Job	Koko	Date	30/03/20
Title	Timber Truss Remedial	Eng.	GGs
Job No.	1444	Sheet	SK240
		Rev.	I01

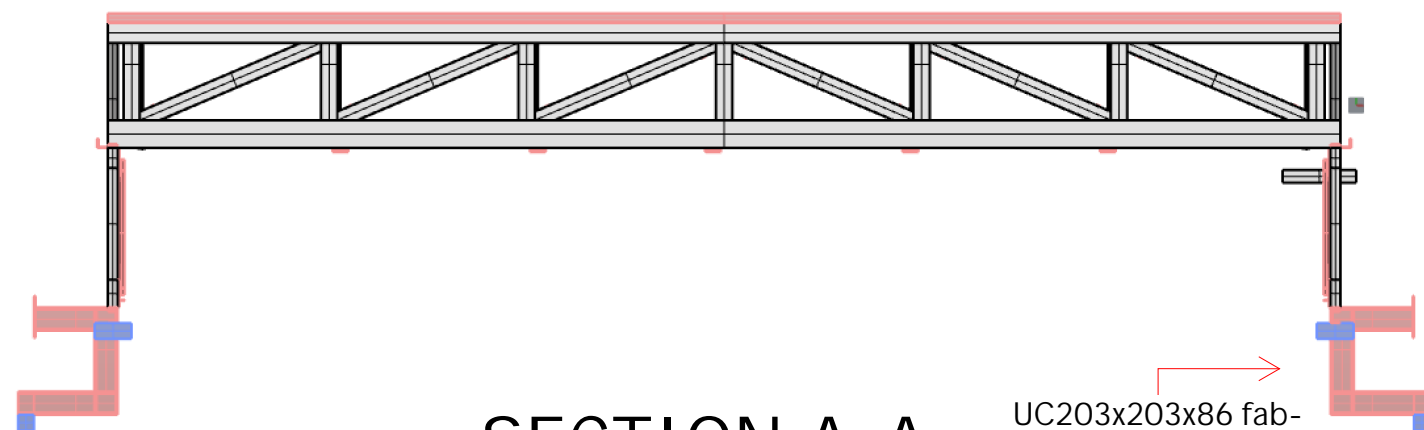
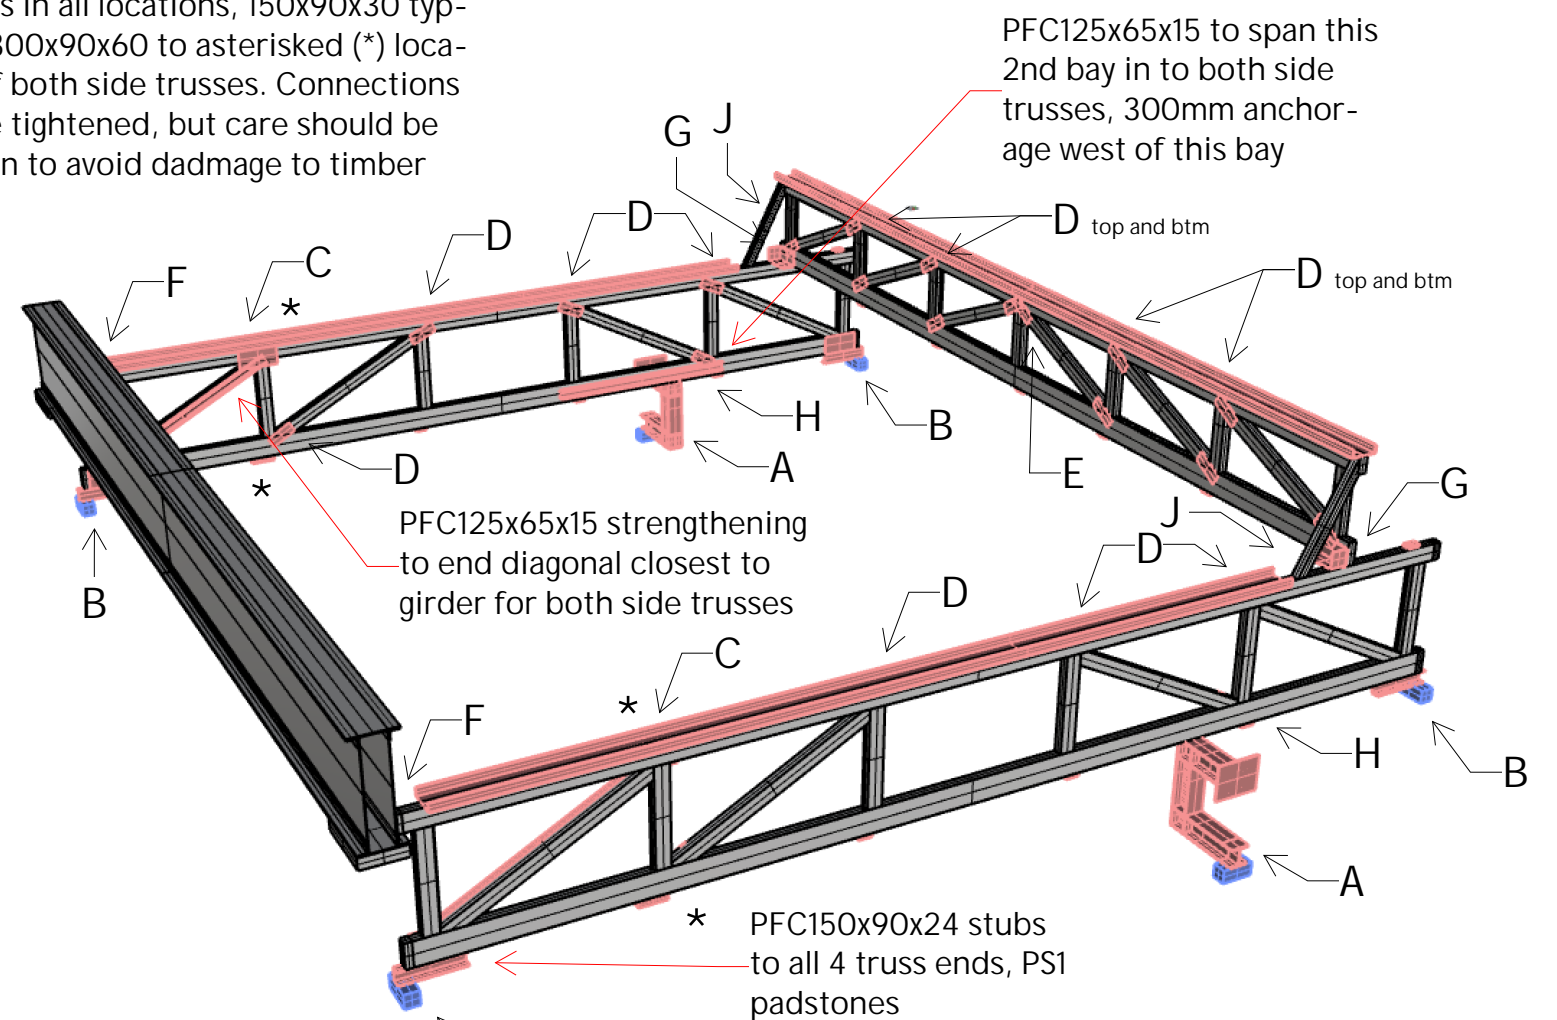
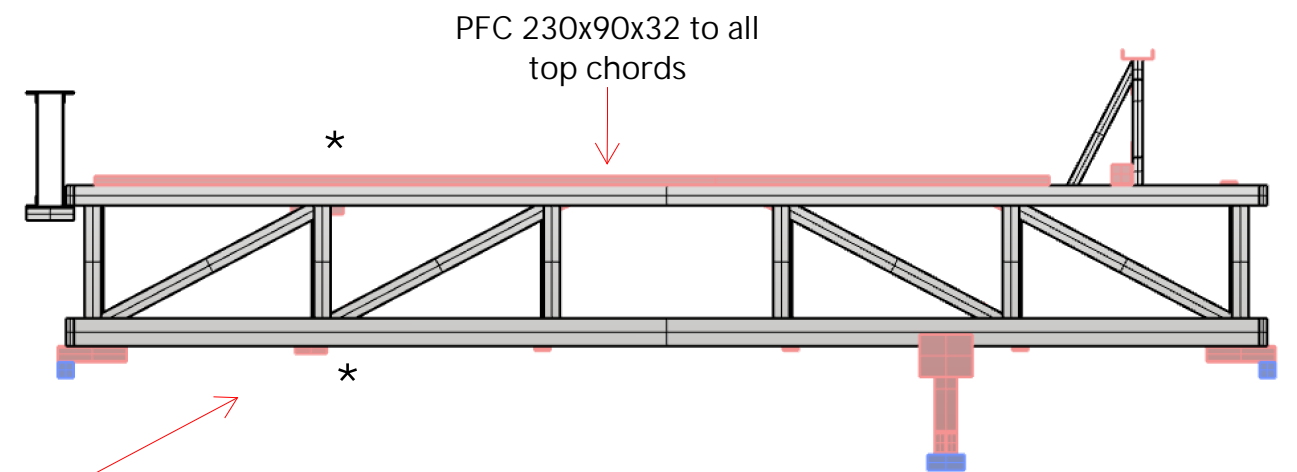
All rods to the 3 trusses to be replaced with 20mm diameter gr.8.8 bars. new washers in all locations, 150x90x30 typically, 300x90x60 to asterisked (*) location of both side trusses. Connections to be tightened, but care should be taken to avoid damage to timber
